# RESPONSE TO COMMENTS

## FINAL ENVIRONMENTAL IMPACT STATEMENT

### Koi Nation of Northern California Shiloh Resort and Casino Project

Sonoma County, California | November 2024

Figure 1. General location of Project parcel.

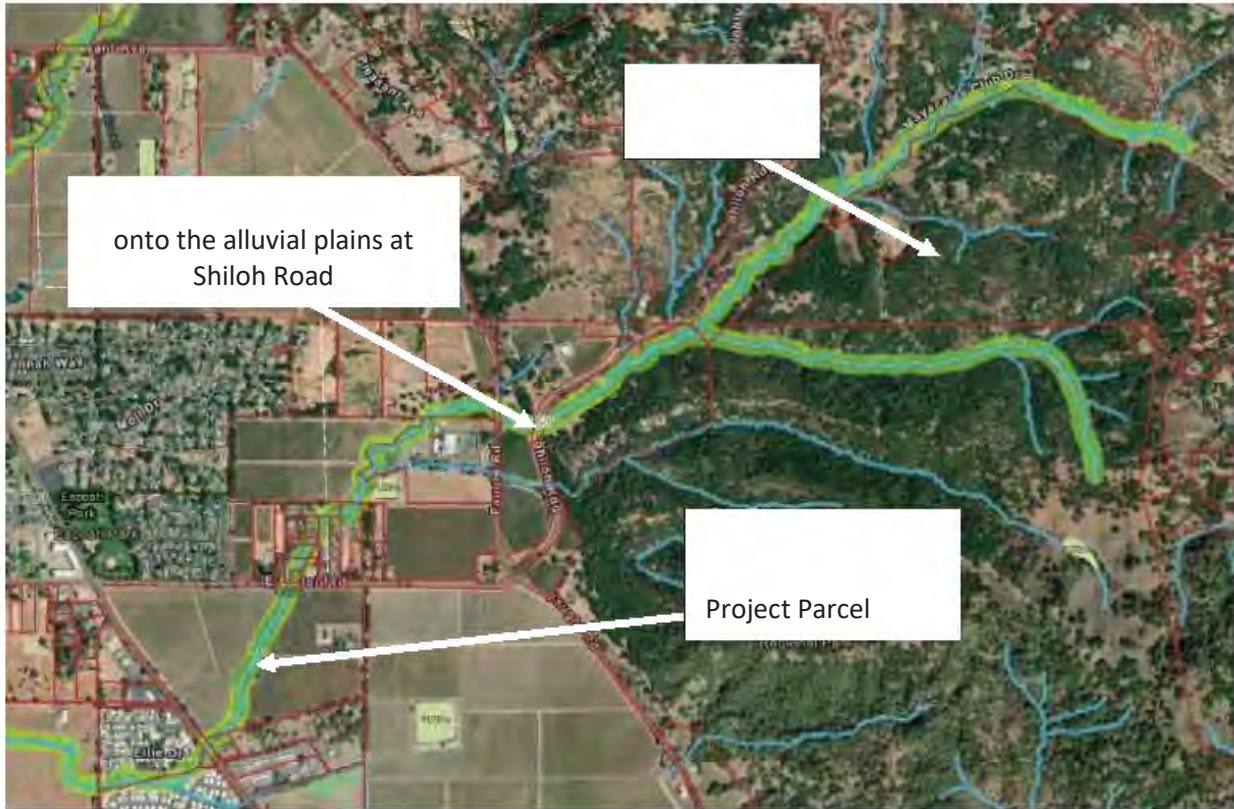
The Project parcel is located in the northeast corner of the Santa Rosa alluvial plains, **within 0.5 miles of the southwest toe of Mayacamas Mountains foothills (Figure 1)**. The **Project site is bisected by from NNE to SSW by Pruitt Creek** and is **basically flat with gentle slopes from east and west sides of parcel towards Pruitt Creek**.

*Figure 1. Location of the ground condition recording sites.*

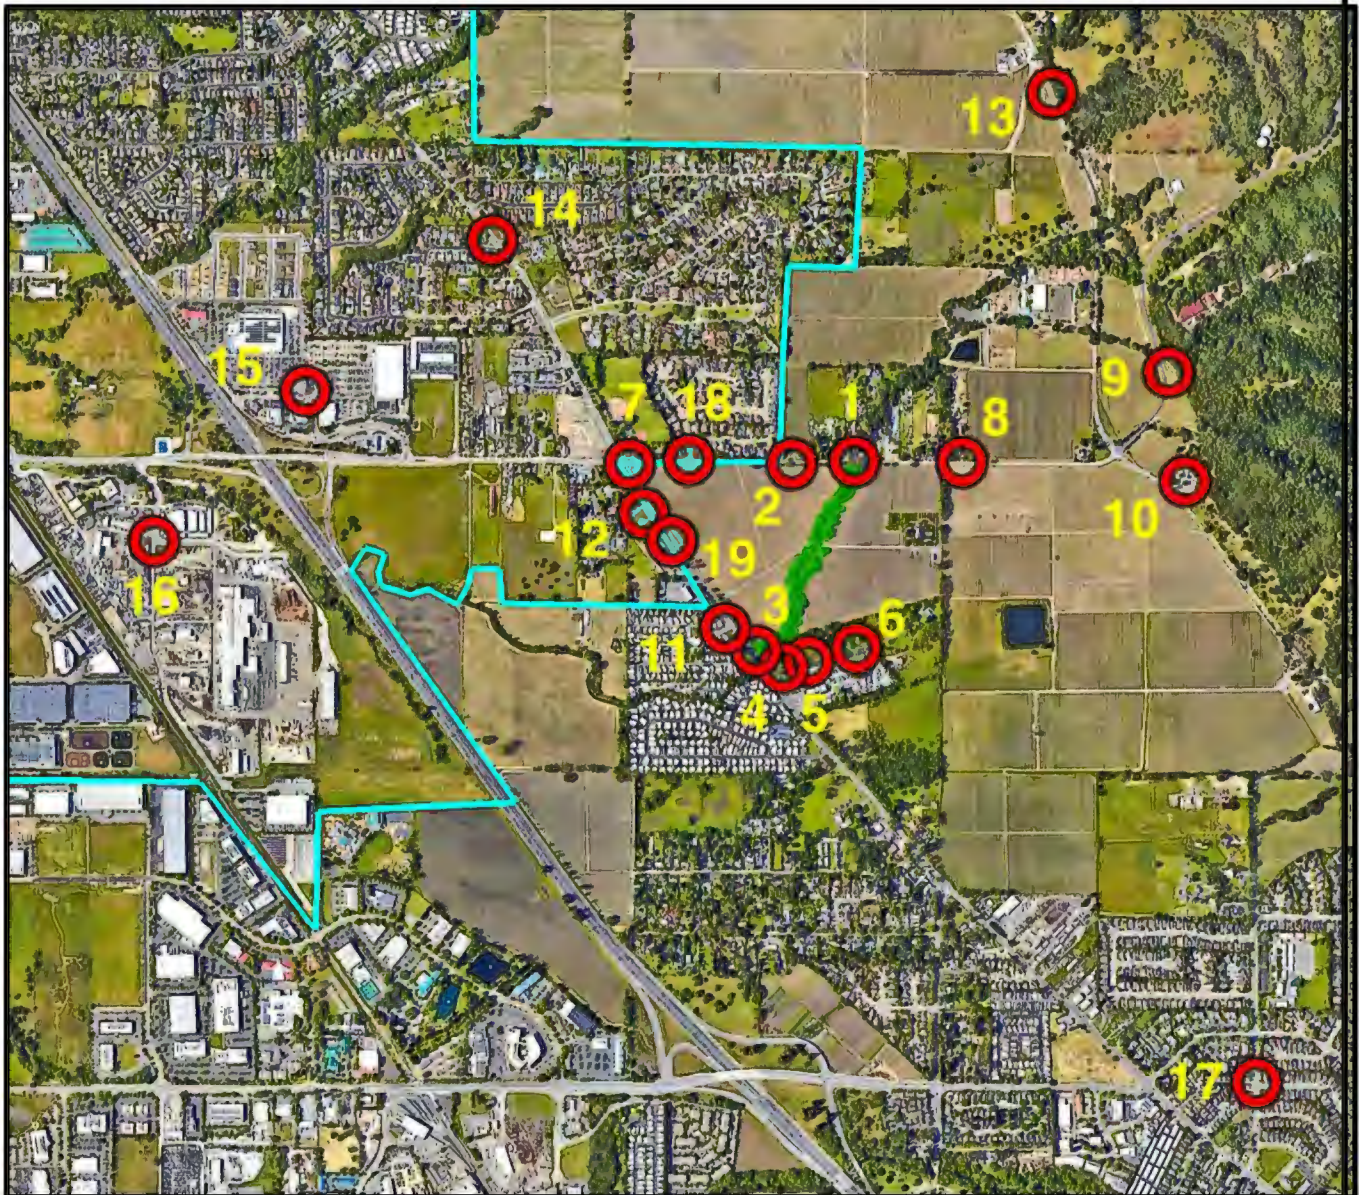
During the course two additional recording sites were added and the full map is shown in Figure 1, below. Each location is indicated by a red circle and sequentially attributed with bright yellow numbers. The city limits of the Town of Windsor are indicated by the bright cyan lines.
